**FPL REPLY TO:**  
**STEAM GENERATOR TUBE INSPECTION DISCUSSION POINTS**  
**PREPARED BY THE OFFICE OF NUCLEAR REACTOR REGULATION**  
**FLORIDA POWER AND LIGHT COMPANY**  
**SAINT LUCIE NUCLEAR PLANT UNIT 2**  
**DOCKET NO. 50-389**

The following discussion points have been prepared to facilitate the phone conference arranged with Florida Power & Light Company to discuss the results of the steam generator (SG) tube inspections to be conducted during the upcoming St. Lucie Nuclear Plant, Unit 2 refueling outage (SL2-16). This phone call is scheduled to occur toward the end of the planned SG tube inspection interval, but before the unit completes the inspections and repairs.

**Status of inspections as of 0800 on 5/5/06 for SL2-16.**

Figure 1 – CY 14 and CY-15 Bobbin Indication Voltages

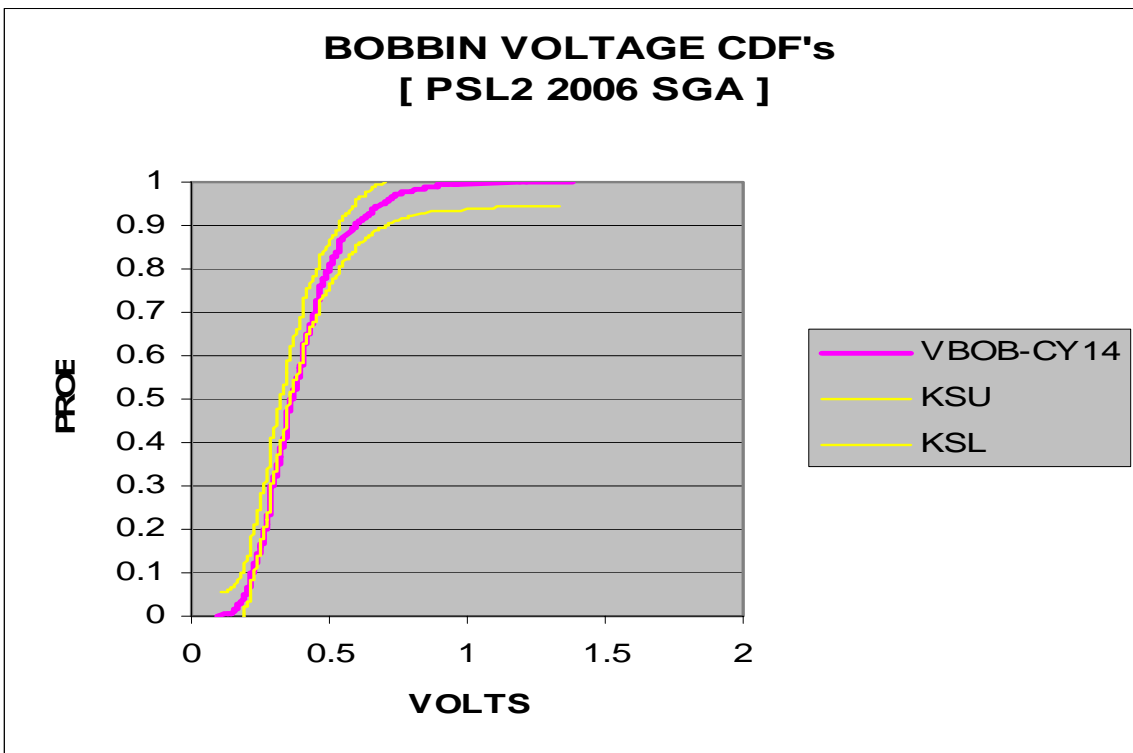
11. Discuss any unexpected or unusual results.

Reply – The only unexpected results is that the number of indications observed in the SGs is lower than expected. The voltage, depth and length distributions are consistent with observations from prior inspections and within expectations (Refer to Figures 1-5).
